Preliminary Infrastructure Assessment

**550-554 Main North Road, Evanston
Park Code Amendment**

| REV NO. | STATUS | AUTHOR | REVIEWED | | APPROVED FOR ISSUE | |
|----------|--|------------------------|-----------------------|-----------------|-----------------------|-----------------|
| D | Revised to address Council Comments | Ghasem Ashtijou | Jordan Colbert | 20.10.22 | Jordan Colbert | 20.10.22 |

FMG Report

Figure 3.4 Predicted inundation during 1% AEP event (long term development scenario) at First Street

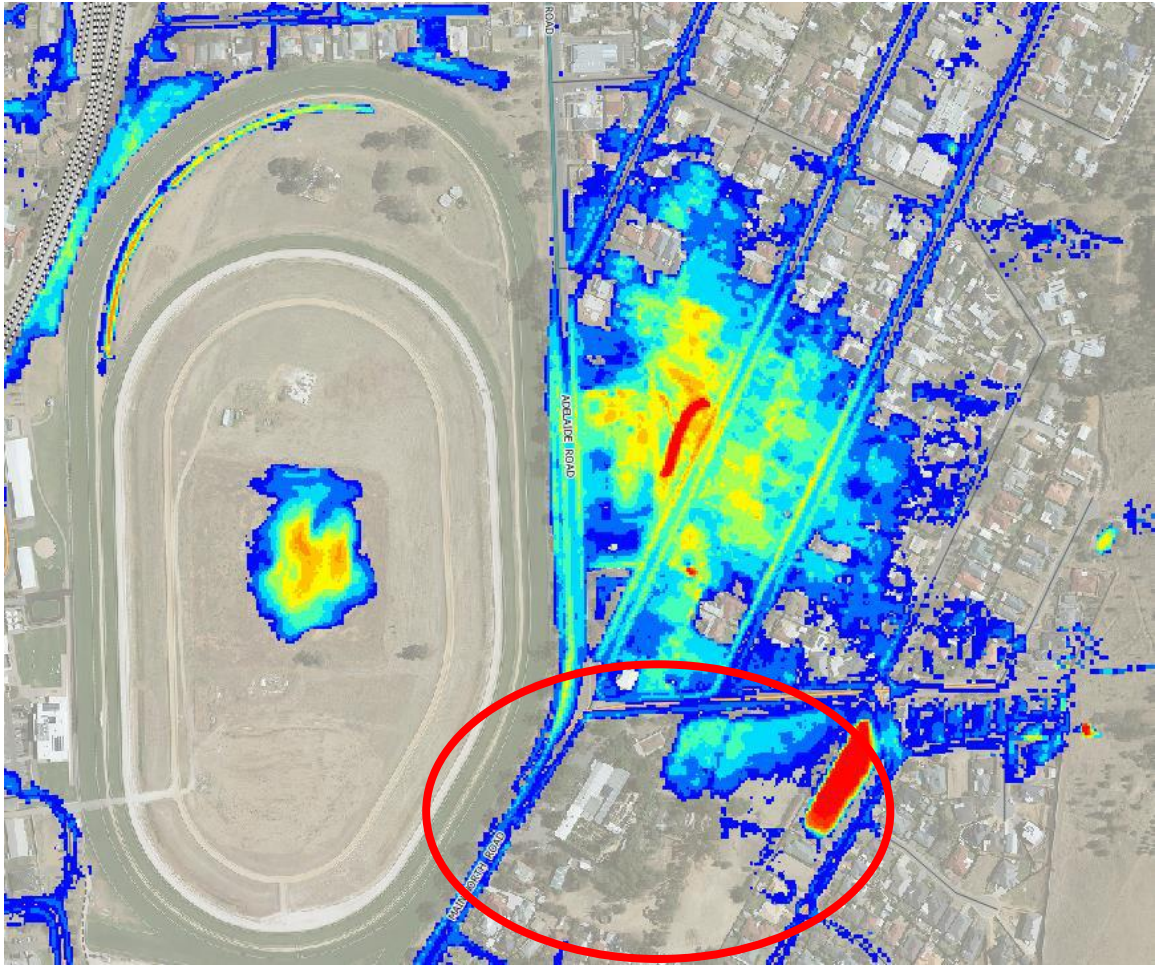
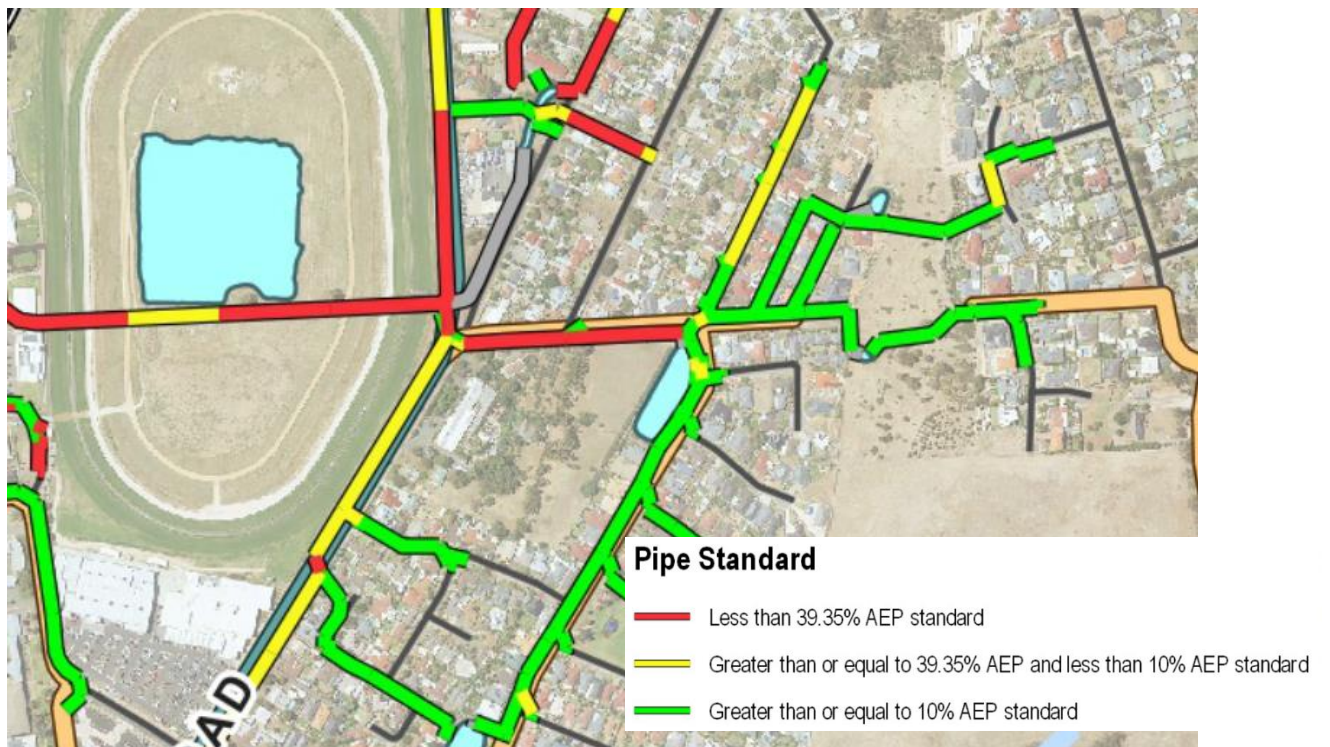
This location is a trapped low spot adjacent the Gawler Racecourse with a predominantly urban catchment of just under 220 hectares. Currently, there is little flooding in the 20% AEP event and only slightly more flooding during the 5% AEP event when stormwater inundates the road. During the 1% AEP event there is significant inundation of the road and surrounding properties (see Figure 3.4), as well as significant sheet flow through properties from Coleman Parade and Mount Terrace. Long-term predictions also show significant inundation and sheet flow through properties during the 5% AEP event.

The primary cause of flooding is the capacity of the pipe system that passes beneath the Gawler Racecourse. This pipe system is the only means of draining the low spot as there are no low-level overland flow routes from this area due to the elevation of the racecourse surface.

This site is on the fringe / partly within the flood plain described above. A development proposing a high impervious site coverage needs to be very carefully considered here, both with respect to protection of the development itself, and ensuring that the development does not exacerbate risk to adjoining land.

Gawler Digital Terrain Model (200mm contours shown)

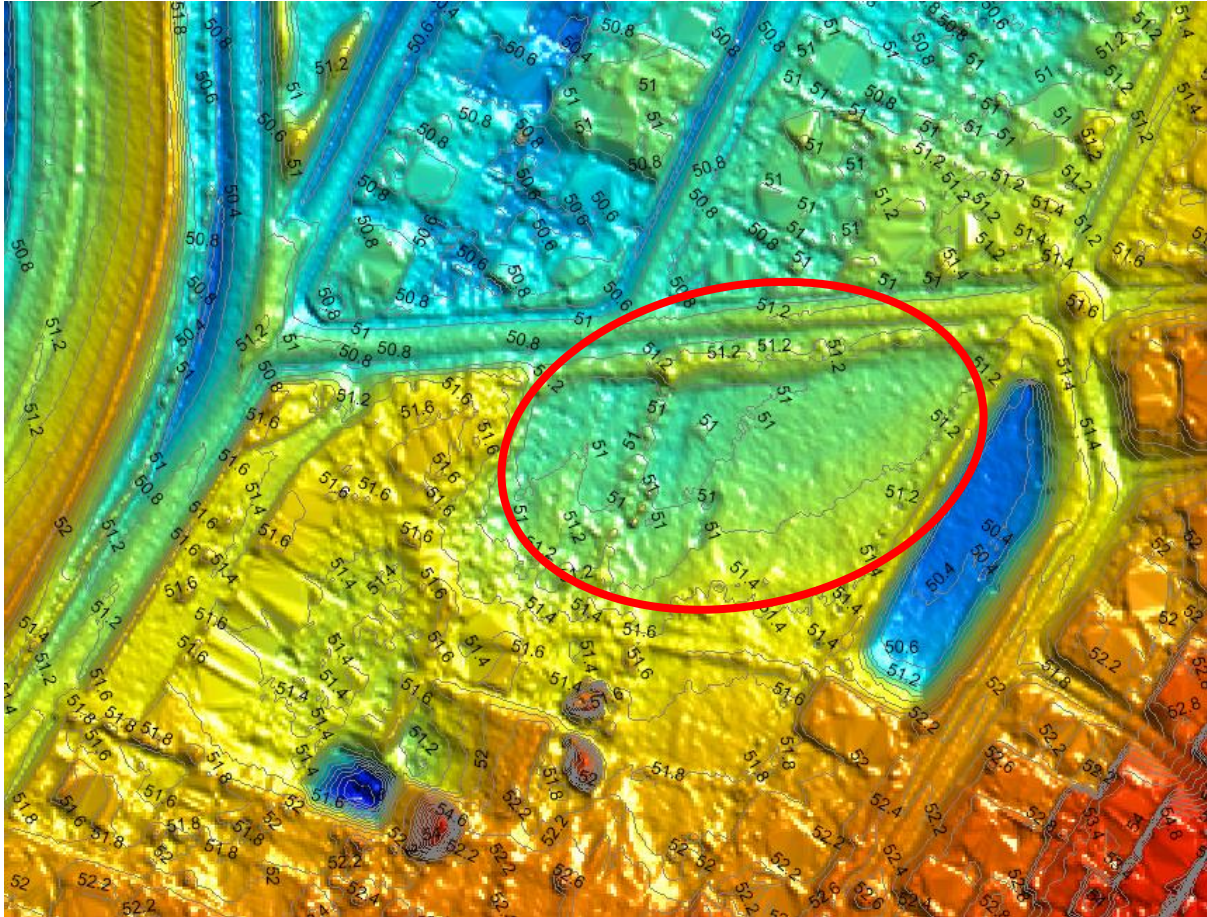
Inspection of the DTM of the area also shows that the part of the site that is flood affected is low-lying – lower than Sheriff Street. It is a “bathtub”, probably connected with the area north of Sheriff Street and hence is naturally vulnerable to flooding.

“Filling” of this low lying area will need to carefully assess whether this will lead to increases in flood risk to adjoining northern floodplain area.
